FIAT SERVICE LETTER

SUBJECT: REAR QUARTER WINDOW

VEHICLES: 128 - 2 DOOR CUSTOM 1976 MODEL

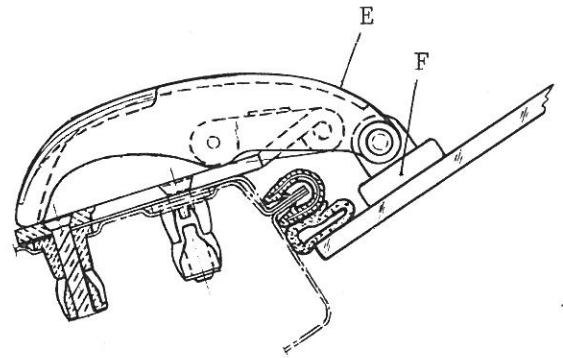
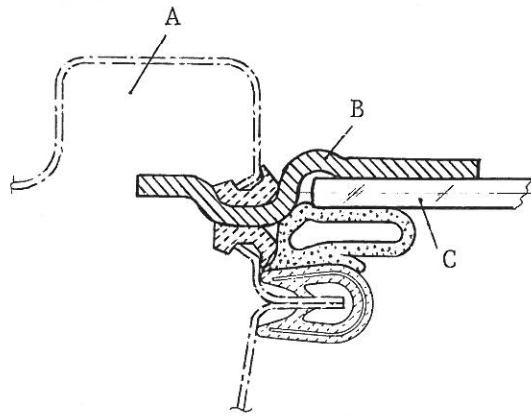
CONDITION: Possible separation of the latch and hinges from the rear quarter window

CAUSE: Improper bond of the latch mounting pin and hinges to the glass.

The mounting pin will no longer be bonded to the glass, but placed through a hole in the quarter window. This new type mounting pin is threaded and is fastened to the window latch by a retaining nut. (see diagram)

The quarter window hinges will also no longer be bonded to the glass, but welded to a "U" shaped pillar, which is pressed on the glass.

CORRECTION: Late production vehicles will be equipped with a modified rear quarter window assembly. This modification involves new window components which are listed below.

Hinges and Handles of Rear Ventilators

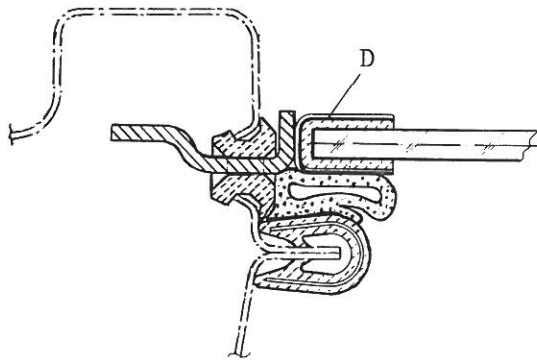
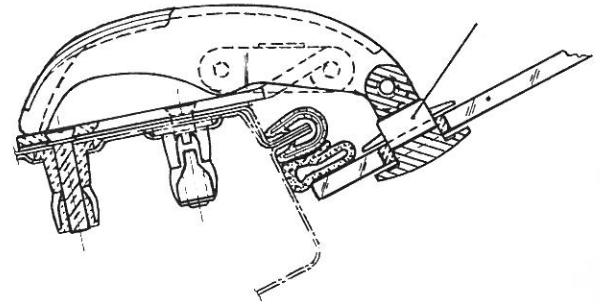
1 - Ante-modification

2 - Post-modification
